Access Compliance Report

Public Rights-of-Way

Intersection ID: 14252	Main Street: BAXTER_ST	Cross Street: CECIL_ST	Location: NW
ADA ID: 95F2EEB38569	Ramp Type: BlendTrans1	Initial Pass/Fail: Fail	Overall Compliance: No
		Severity Score: 12.5

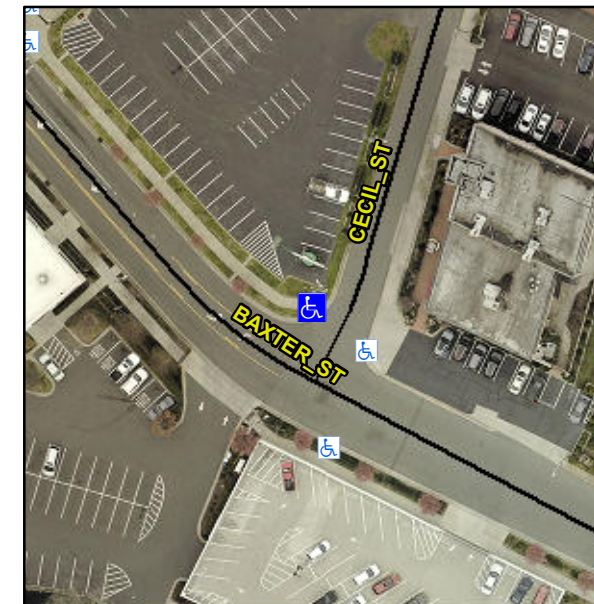
Compliance	Description	Data	Compliance	Description	Data
N/A	Ramp Length (in)	51.0	Yes	BlendTrans Slope (%)	3.4
Yes	Ramp Width (in)	48.0	No	BlendTrans XSlope (%)	6.1
N/A	Flare Type LT	N/A	N/A	Flare Type RT	N/A
N/A	Flare Slope LT (%)	N/A	N/A	Flare Slope RT (%)	N/A
N/A	Flare Traversable LT?	N/A	N/A	Flare Traversable RT?	N/A
N/A	Landing Length (in)	N/A	N/A	DWS Provided?	N/A
N/A	Landing Width (in)	N/A	N/A	DWS Contrast?	N/A
N/A	Landing Slope (%)	N/A	N/A	DWS Length (in)	N/A
N/A	Landing X Slope (%)	N/A	N/A	DWS Full Width?	N/A
N/A	Landing Curb? (Y/N)	N/A	N/A	DWS Offset (in)	N/A
N/A	Shared Landing?	N/A			
N/A	Gutter Ponding?	N/A	N/A	Gutter Slope (%)	N/A
N/A	Gutter Lip Ht (in)	N/A	N/A	Gutter X Slope (%)	N/A
N/A	Painted X Walk1?	No	N/A	Painted X Walk2?	No
	X Walk 1 Direction	To SW		X Walk 2 Direction	To SE
	X Walk 1 Width (in)	N/A		X Walk 2 Width (in)	N/A
	X Walk 1 Slope (%)	1.3		X Walk 2 Slope (%)	6.9
	X Walk 1 X Slope (%)	8.7		X Walk 2 X Slope (%)	0.5

Remove & Replace Curb Ramp With Two New Directional Ramps or Equivalent.
